6. DEFECT SCHEDULE

CLIENT: THE OWNERS – STRATA PLAN NO. 102187
PROPERTY ADDRESS: 11 MITCHELL AVENUE, JANNALI NSW 2226
BUILDER: TRULAND DEVELOPMENT, FORTE SYDNEY FUND MANAGEMENT, FORTE SYDNEY
CONSTRUCTION, FORTE SYDNEY NSW CONSTRUCTION, XIAOLU LI
DEVELOPER: MITCHELL AVENUE DEVELOPMENT PTY LTD

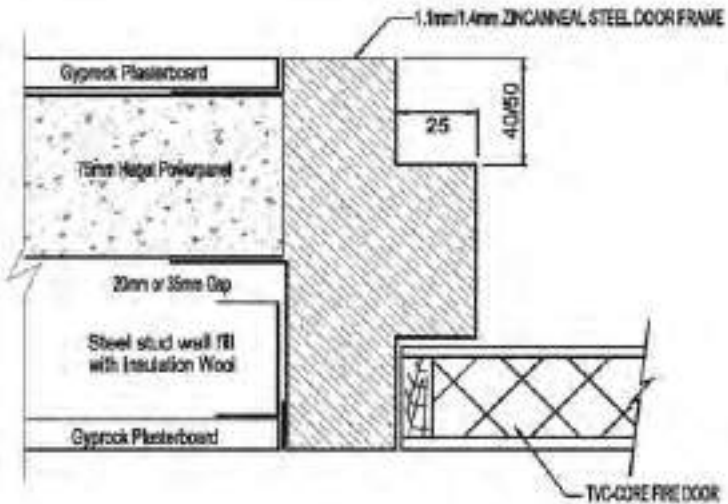
The door to the NBN room on Level LG has a tagged fire door, but is installed in a non-fire rated frame.

To comply with Clause C3.11 of the BCA a doorway in a Class 2 part of the building must be protected with a fire door having a FRL of at least -/60/30 if it provides access to a room not within a sole occupancy unit to a public corridor, public lobby or the like.

To comply with Clause C3.4, fire doors (where required) must comply with Spec C3.4, which requires fire doors to comply with AS1905.1.

It is also noted that the Door Schedule (Drawing No. A6102) details this door as having a FRL of -/120/30.

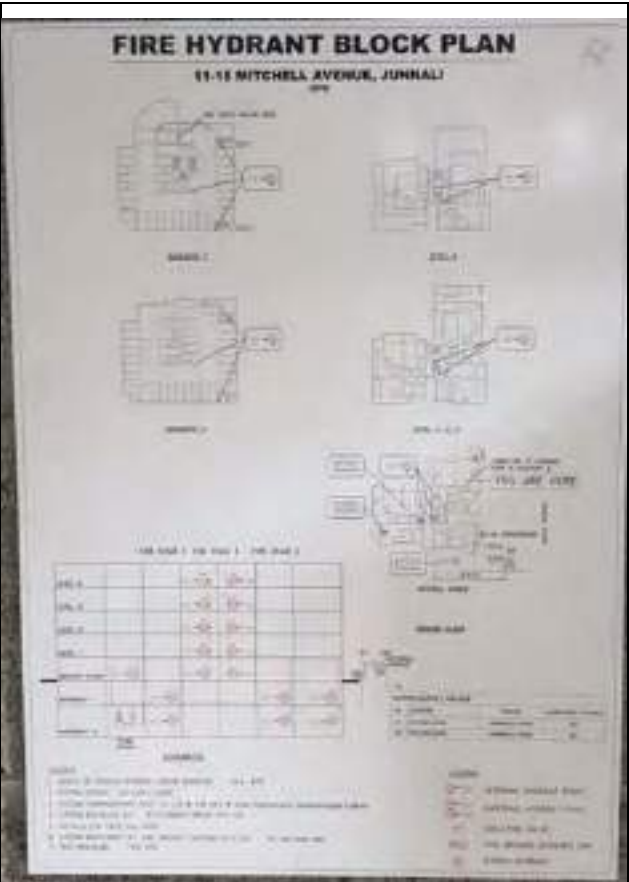
6.6.2.	DEFECT	HYDRANT BLOCK PLANS DO NOT INCLUDE DESIGN FLOWS				
	DESCRIPTION	<p>Hydrant block plans at the booster connection, booster pump and fire indicator panel do not include the design flows.</p> <p>According to the Sydney Water pressure and flow enquiry, a flow rate of 12L/sec can only be achieved.</p> <p>Therefore the Fire Engineering Report 138309.FER001b provides a Performance Solution to permit one hydrant flowing rather than the BCA minimum of two hydrants flowing for the carpark area, which would otherwise be based on the floor area of the carpark and would require a flow rate of 20L/sec.</p> <p>To comply with Clause 1.4 Schedule of Works in the Fire Engineering Report (refer Item 3.2 in Table 1.2), the block plan for the hydrant system is to state the design supply flows and pressures.</p> <table border="1" data-bbox="539 571 1541 703"> <tr> <td data-bbox="539 571 757 703">3.2 - Hydrant Signage</td> <td data-bbox="757 571 1339 703">The block plan for the hydrant system is to state the design supply flows and pressures, as well as show the proposed carpark separation, access points to each fire compartment, and corresponding fire hydrant locations.</td> <td data-bbox="1339 571 1541 703">Architect / Fire Services Contractor</td> </tr> </table>		3.2 - Hydrant Signage	The block plan for the hydrant system is to state the design supply flows and pressures, as well as show the proposed carpark separation, access points to each fire compartment, and corresponding fire hydrant locations.	Architect / Fire Services Contractor
3.2 - Hydrant Signage	The block plan for the hydrant system is to state the design supply flows and pressures, as well as show the proposed carpark separation, access points to each fire compartment, and corresponding fire hydrant locations.	Architect / Fire Services Contractor				
	LOCATION(S)	<p>Fire brigade booster connection</p> <p>Fire hydrant pump room on B1 level</p> <p>Adjacent the fire indicator panel</p>				
	BREACH(ES)	<p>Failure to comply with:</p> <ol style="list-style-type: none"> 1 Home Building Act 1989 NSW under Section 18B Clauses (a) & (c) 2 BCA – Performance requirement EP1.3 3 Item 3.2 in Table 1.2 of Fire Engineering Report 138309.FER001b 				
	METHOD OF REPAIR	<p>The fire hydrant block plans at all three locations will need to be amended to state the design pressures and flows.</p>

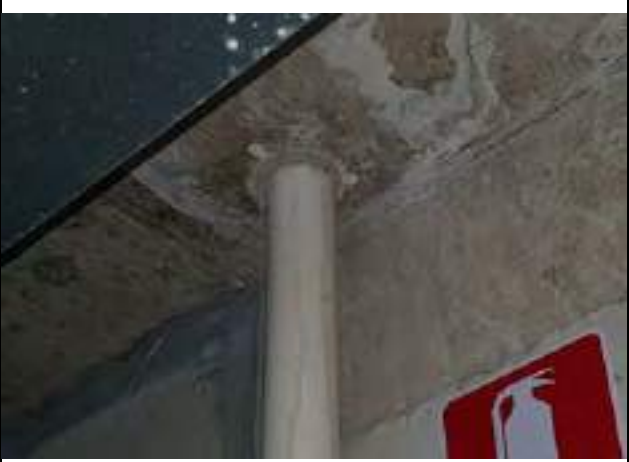
6.8.3.	DEFECT	PVC CONDUITS NOT FIRE STOPPED
	DESCRIPTION	<p>The conduit for the fire detection system has not been adequately fire stopped where it passes through the walls to the hydrant pump room.</p> <p>To comply with C3.15 of the BCA, service penetrations through fire rated construction must be identical to a tested prototype that has been tested in accordance with AS4072.1 & AS1530.4.</p> <p>An acrylic mastic has been used to partially seal these conduits, however there is no tested system that achieves the required FRL using acrylic mastic to seal electrical conduits.</p>
	LOCATION(S)	<p>Hydrant pump room wall Hydrant pump room airlock wall</p>
	BREACH(ES)	<p>Failure to comply with:</p> <ol style="list-style-type: none"> 1 Home Building Act 1989 NSW under Section 18B Clauses (a) & (c) 2 BCA – Clause C3.15 – Openings for service installations 3 Manufacturer’s tested or approved system
	METHOD OF REPAIR	<ol style="list-style-type: none"> 1 Either: <ol style="list-style-type: none"> a. Install suitable fire collars to the PVC conduit, on both sides of the wall. <p>OR</p> <ol style="list-style-type: none"> b. Cut back conduit and remove section of conduit where it passes through the wall. Then reseal the cable using an acrylic fire rated mastic where it passes through the wall

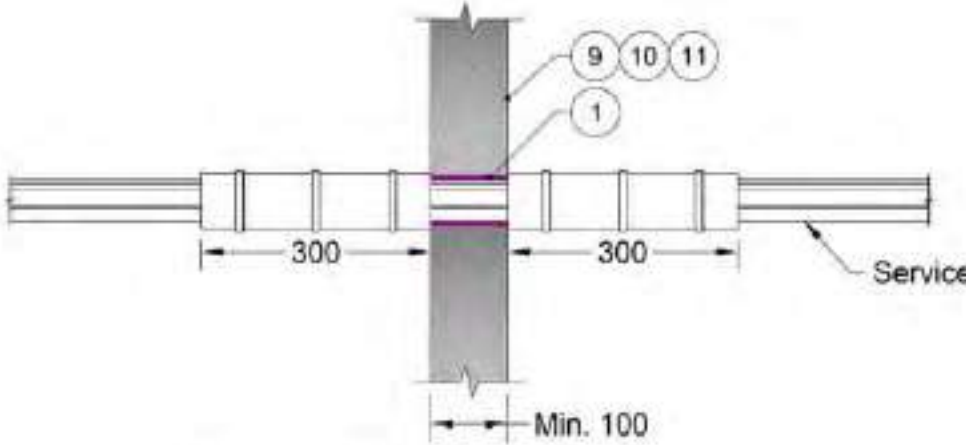
6.8.9.	DEFECT	POTENTIAL DAMAGE TO INSULATION WRAP	
	DESCRIPTION	<p>Two copper and steel pipe penetrations through the slab outside the south fire stair have water pooling around the penetration.</p> <p>It is not clear at this stage if the insulation wrap surrounding these pipes has deteriorated to a point where it is ineffective in providing the required insulation rating, however the integrity of the wrap should be inspected once the issue causing the water to pool in this area has been resolved.</p> <p>Manufacturer recommends that wrap is installed in dry locations and has advised that continual exposure to water may result in the foil delaminating from the core material of the wrap.</p> <p>Additionally there is an obvious potential for pipe corrosion in future.</p> <p>FURTHER INVESTIGATION OF THE WATER SOURCE AND RECTIFICATION IS REQUIRED</p>	
	LOCATION(S)	Level B1 outside south fire stair

BREACH(ES)	<p>Failure to comply with:</p> <ol style="list-style-type: none"> 1 Home Building Act 1989 NSW under Section 18B Clauses (a) & (c) 2 BCA – Clause C3.15 – Openings for service installations 3 Manufacturer’s recommendations 	
	METHOD OF REPAIR	<ol style="list-style-type: none"> 1 Resolve the issue causing the water to pool in this area. 2 Inspect Penowrap insulation for deterioration. 3 Replace if deemed necessary.

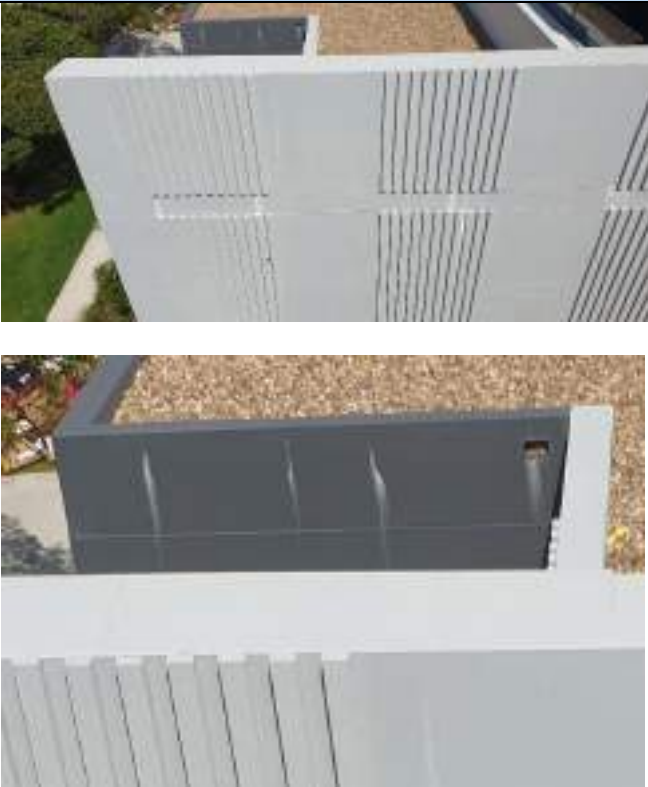
ITEM	COMMENTARY	PHOTOGRAPH(S)
C - 1		
A	<p>Location & Description Door installation – Waterstop and weatherproof flashing</p> <p>The Author has observed that no water stop has been provided to the doors to all units.</p> <p>The Author noted that the defect was identified in Section 8.3 of the Construction Adviser (Giaouris) Report.</p> <p>The Author concurs with Giaouris view that the installation has not been carried out in accordance with AS4654.2.</p> <p>The Author is of the view that the defect is systematic failure of the Builder to carry out the works with due care and diligence in accordance with AS4654.2 and the NCC Volume 1 2016.</p> <p>The Author noted that the NCC Volume 1 2016 Part F1.4 states –</p> <p><i>Waterproofing membranes for external above ground use must comply with AS 4654.1 and AS4654.2; and that the</i></p> <p><i>Performance Requirements FP1.4 Weatherproofing require - A roof and external wall (including openings around windows and doors) must prevent the penetration of water that could cause—</i></p> <p><i>(a) unhealthy or dangerous conditions, or loss of amenity for occupants; and</i></p> <p><i>(b) undue dampness or deterioration of building elements.</i></p> <p>The Author is of the view that based on the NCC Verification Methods FV1.1 Weatherproofing methods of assessing and testing that where the doors have been installed there is a Very high Risk Severity that door installation is defective.</p> <p>It then follows that the doors identified by the Author in Table C-1-1 of this item in relation to the defective works should be rectified to comply with requirements of the NCC and AS4654.2.</p>	 <p>Unit G02 Bed 2</p>  <p>Unit G03 No waterstop</p>  <p>Unit G04 Bed 2</p>

B	<p>Cause(s)</p> <ul style="list-style-type: none"> • Failure of the Builder to carry out the works with due care and diligence.

C-2 Description Photograph(s)

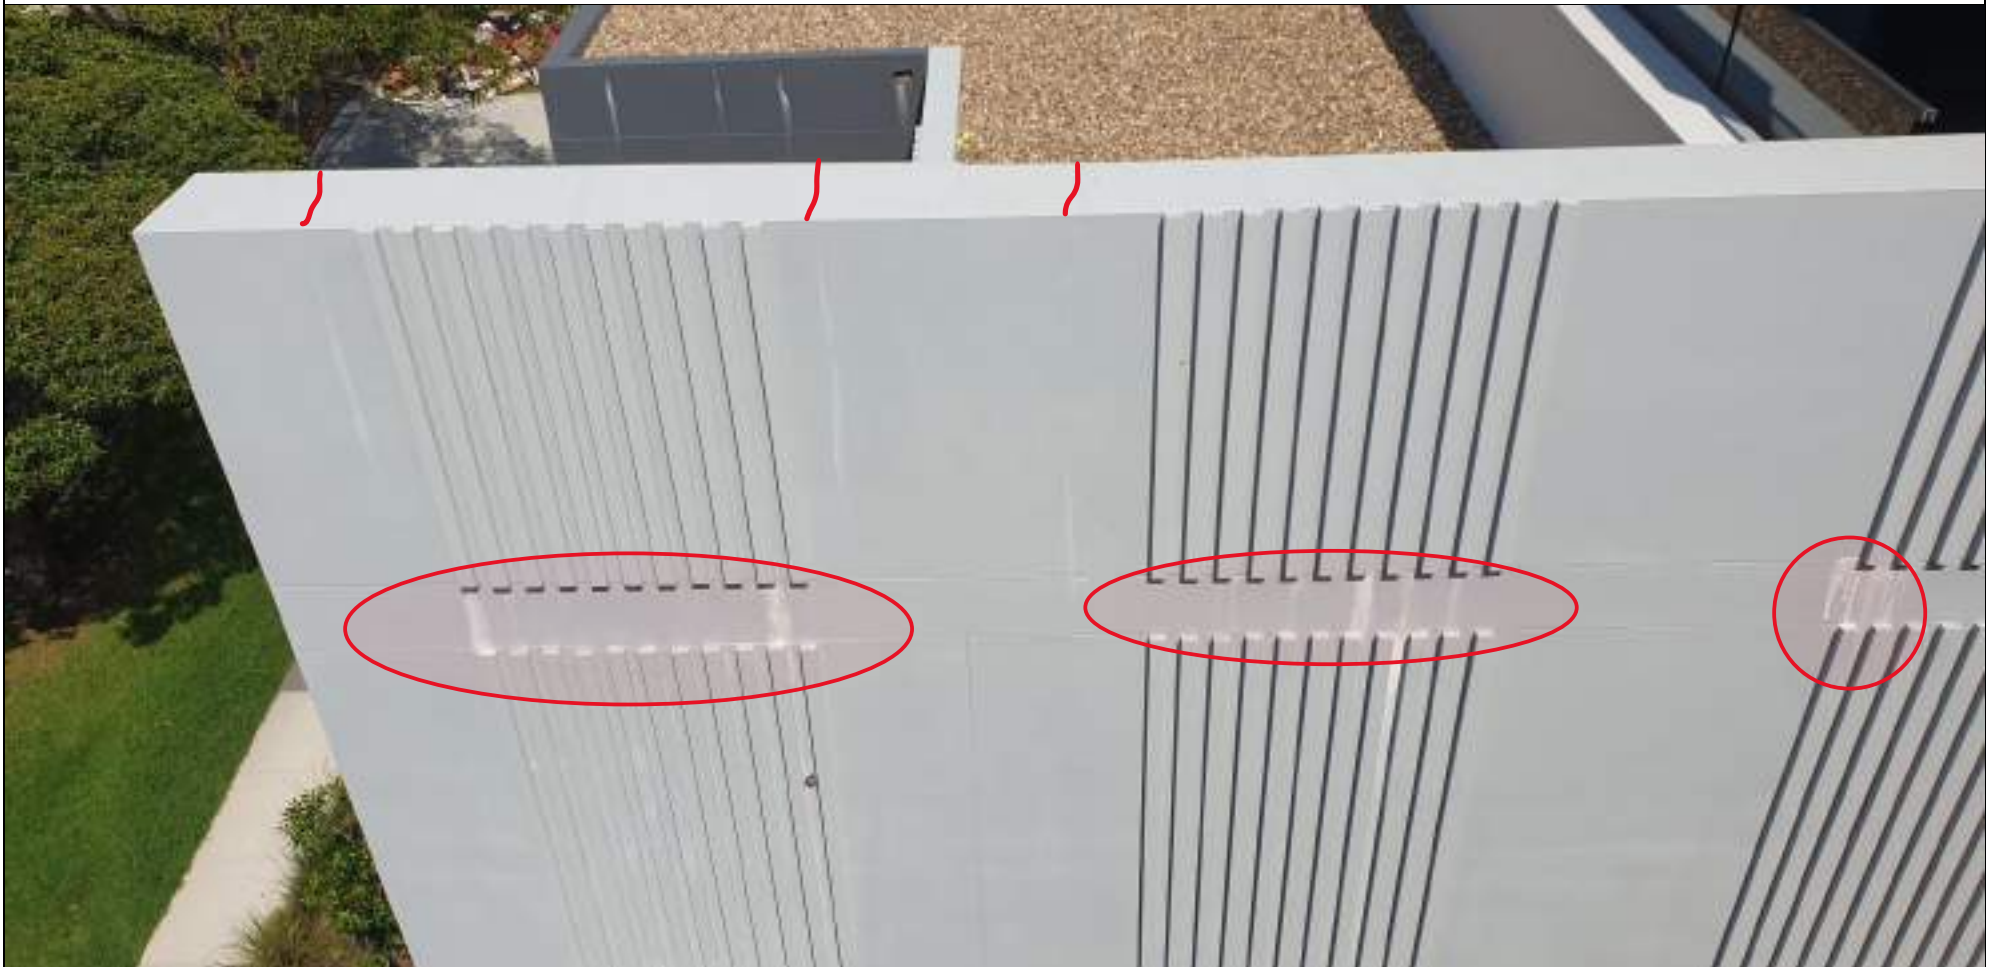
Efflorescence staining to western of building U façade above entry inline with cracks on top of façade parapet indicated in and horizontal joint

D	<p>Proposed Rectification Scope of Works</p> <p>Allow to:</p> <ol style="list-style-type: none">1. Provide site supervision. Supervisor to coordinate access and facilitate the works throughout the whole process.2. Gain access to required areas in accordance with Safework requirements.3. Supply and install scaffold in hard to reach areas4. Supply and install custom made powder coated metal flashing to parapets and roof perimeter5. Supply fixings, sealants, and ancillaries6. Labour to remove efflorescence staining and repair paint finish to nearest junction and make good, affected finishes7. Supply paint, cleaning materials and ancillaries8. Dismantle and remove scaffold9. Labour to place waste material in waste bin, clean site and leave in a tidy condition upon completion of work10. Dispose of building waste	
---	--	---

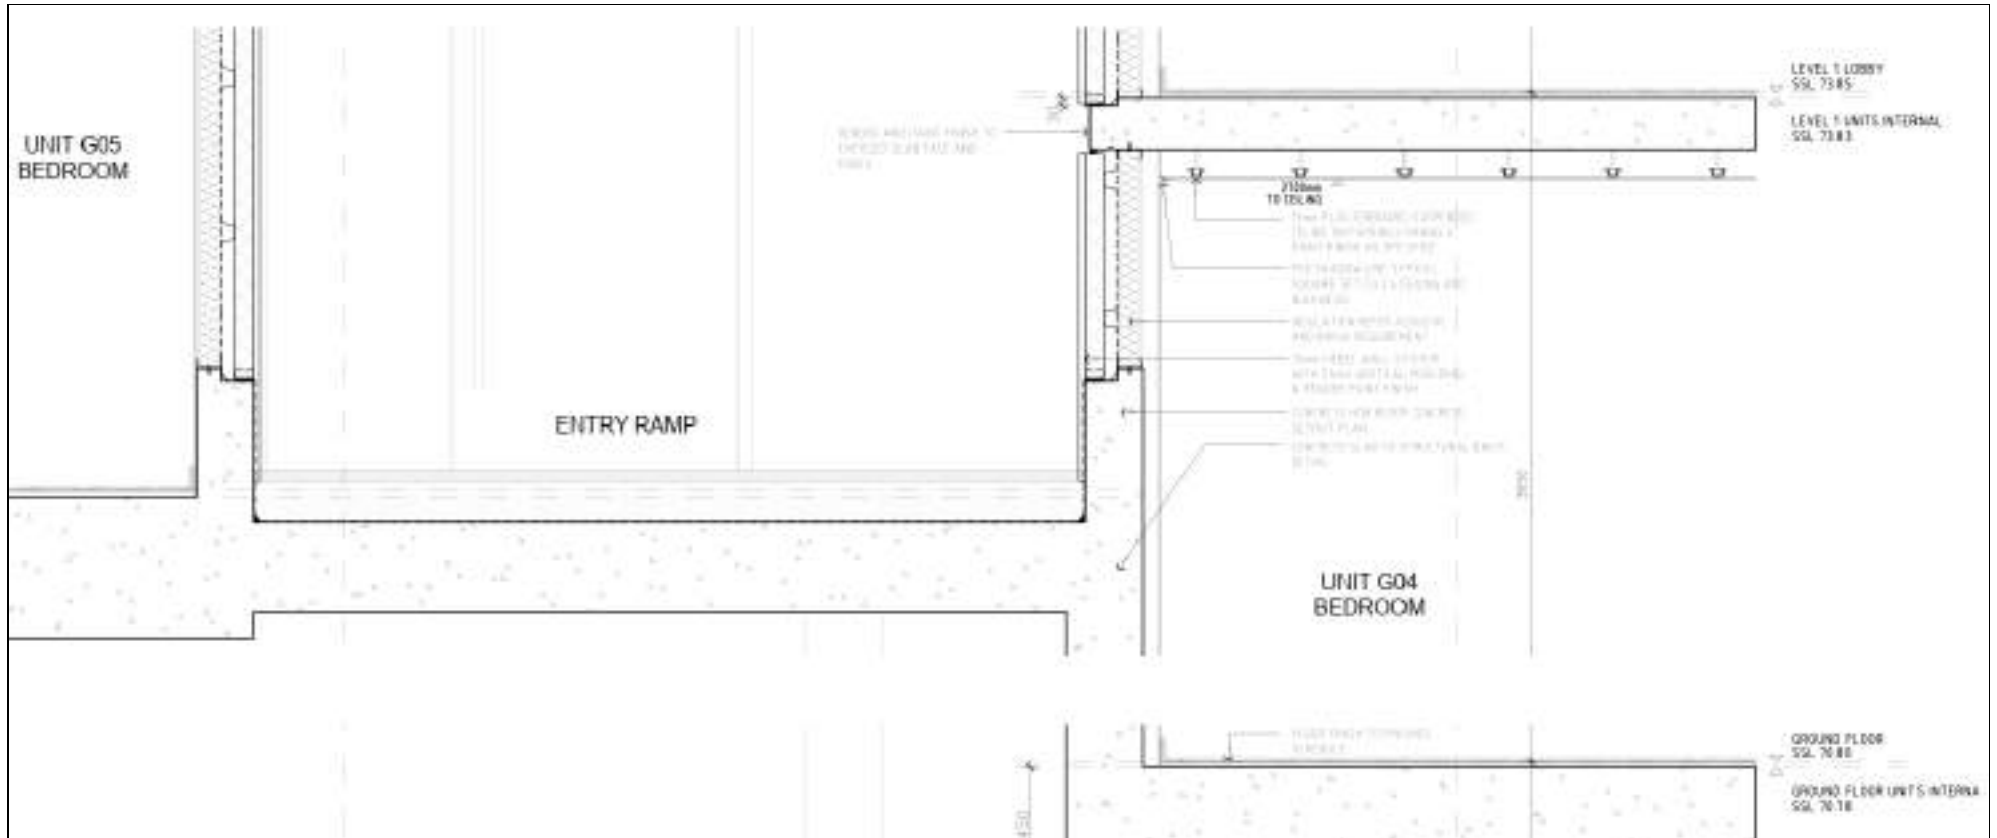
Render finish applied to waterproofing is drummy

Weepa's installed to base of wall have no useful function

Weepa's installed to base of wall have no useful function

Waterproofing applied over stormwater grate

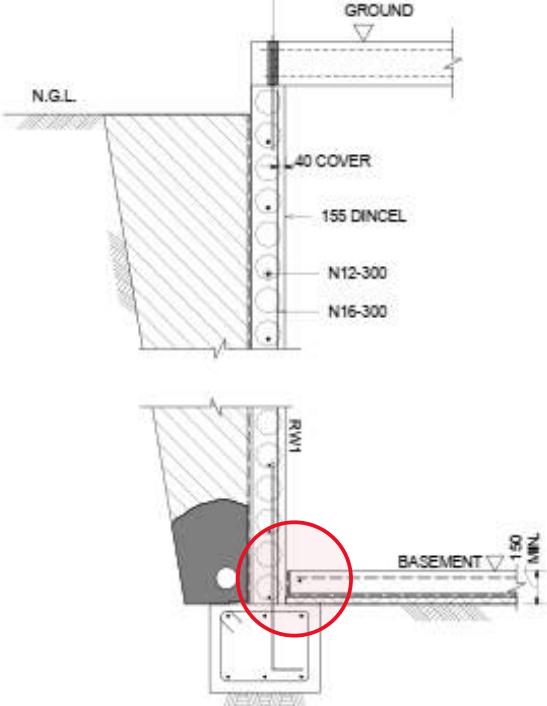
ITEM	COMMENTARY	PHOTOGRAPH(S)
B1-1		
A	<p>Location & Description Basement level 2 Stairs - Eastern wall</p> <p>The Author has observed that there following rain, water is penetrating location of the Dintel wall at –</p> <ol style="list-style-type: none"> 1. To the northern wall above stair landing Basement 2 level of the Fire stair 2 <ol style="list-style-type: none"> 1. The Author conducted a percussion test in the location of the water leak above stair landing Basement 2 level of the Fire stair 2 and found the location of the leak to be drummy. The Author is of the view that the percussion test indicated there is a concrete void in the core of the Dintel in the location of leak. <p>The Author is also of the view that as the stormwater drain at the to the ground level door has not been fully sealed at both end of the top of the grated drain allows rainwater to flow above the location of leak to the Dintel wall.</p> <ol style="list-style-type: none"> 2. At the base of the wall to the southern wall at Basement 2 level of Fire stair 2 <ol style="list-style-type: none"> 2. In relation to the water leak at the base of the wall to the southern wall at Basement 2 level of Fire stair 2, the found that the Dintel wall had not been set down below the slab as to the manufacturers guidelines. <p>The Author is of the view that the Builder has failed to carry out the works in accordance with the manufacturers installation guidelines and engineers design, and that the defects originated due to poor workmanship employed by the Builder at the time of construction.</p>

B	<p>Cause(s)</p> <ul style="list-style-type: none"> • Poor workmanship employed by the Builder at the time of construction. 	<p>Water pooling on floor due to water leak from Dintel at northern wall above stair landing Basement 2 level of the Firestair 2</p>
C	<p>Breach(es) Failure to comply with the following:</p> <ul style="list-style-type: none"> ▪ Home Building Act 1989 (NSW) under Section 18B Clauses 1(a) ▪ Manufacturers guidelines ▪ Plans and specifications

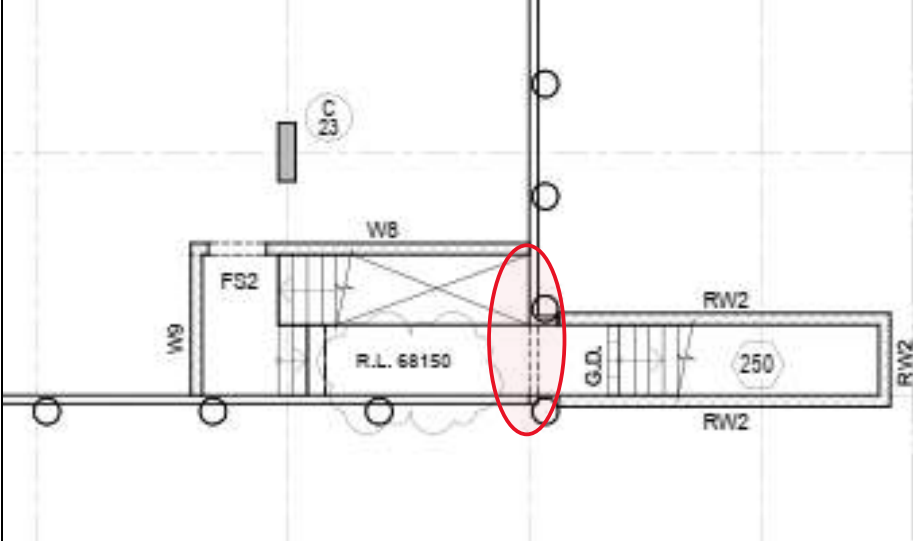
Water pooling on floor at Basement 2 level in Stairway 2 orinating from water leak to northern wall above stair landing

Water penetrating base of Dintel to southern wall in Stairway 2 at Basement 2 level

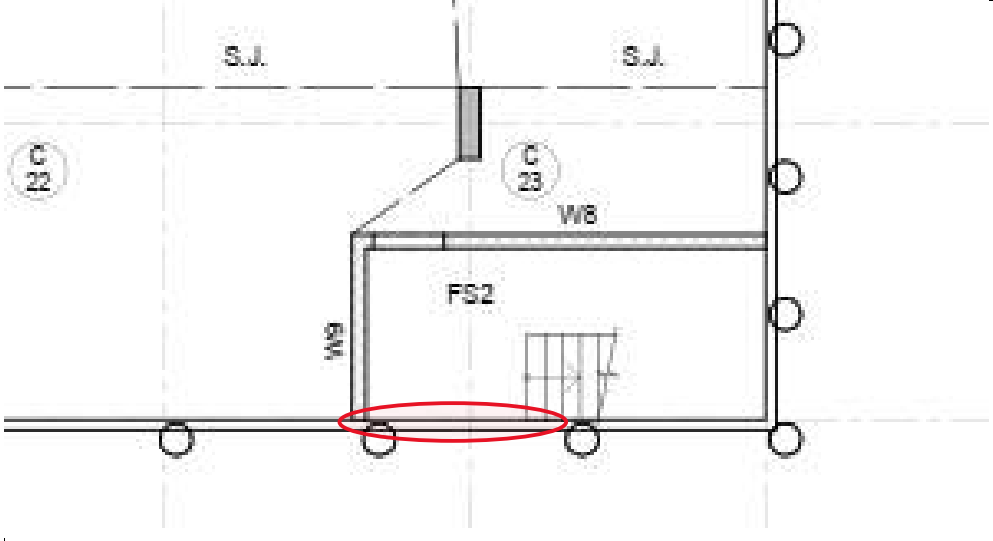
Water penetration identified at stair landing on eastern wall above basement level 1

Location of water penetration at eastern wall on stair landind above basement level 1
